# PLAN COMMISSION STAFF REPORT

**Agenda Item:** PC Docket No. 22-013

**Application:** **Zoning Amendment – Planned Unit Development Amendment**

**Summary:** Maple Leaf Crossing LLC requesting approval of an amendment to the Maple Leaf Crossing Planned Unit Development to permit a restaurant and cigar lounge on Lot 7 in the Maple Leaf Crossing PUD at 9410-9470 Calumet Avenue

#### SITE PLAN MODIFICATIONS

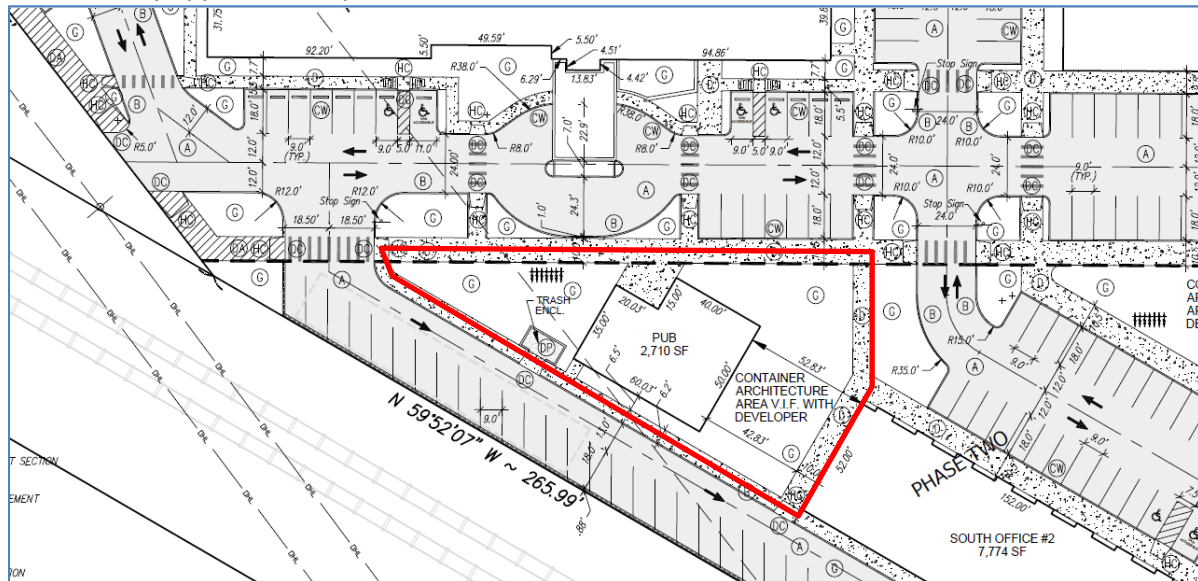
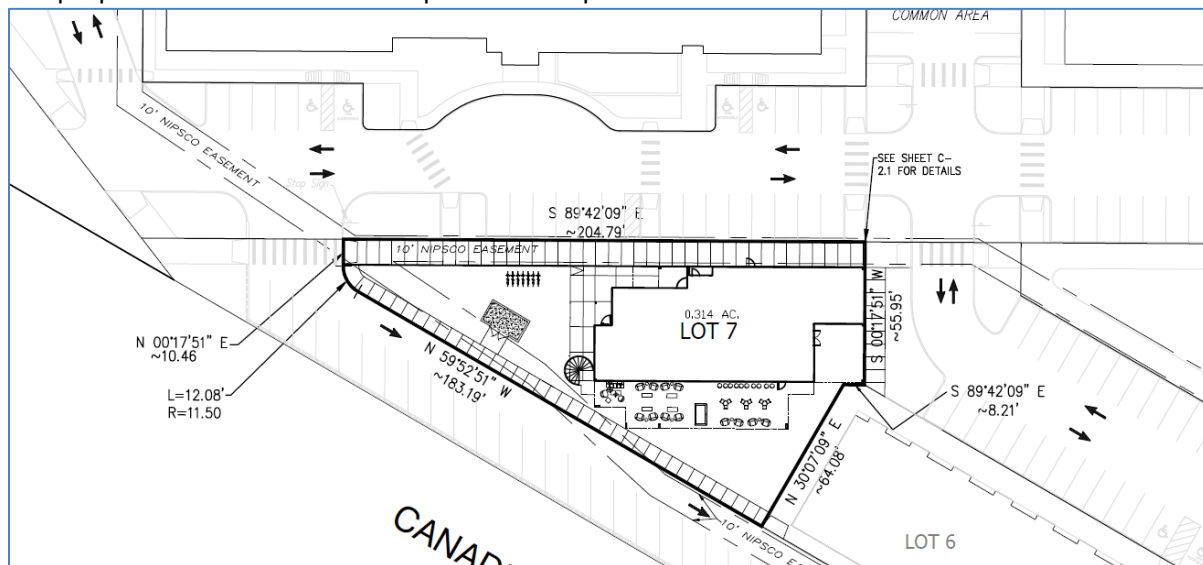
Ordinance 1803 specifies that Lot 7 will be developed with a 2710 square foot pub and repurposed shipping containers. The developers are seeking an amendment to the Maple Leaf Crossing PUD development standards and approved site plans to replace the 2,710 square foot pub and shipping containers with the proposed cigar bar. The proposed amendment would supersede any previously adopted landscape plans and architectural and design standards for Lot 7.

The currently approved site plan for Lot 7 is shown below:

The proposed amendment will adopt a new site plan for Lot 7 shown here:
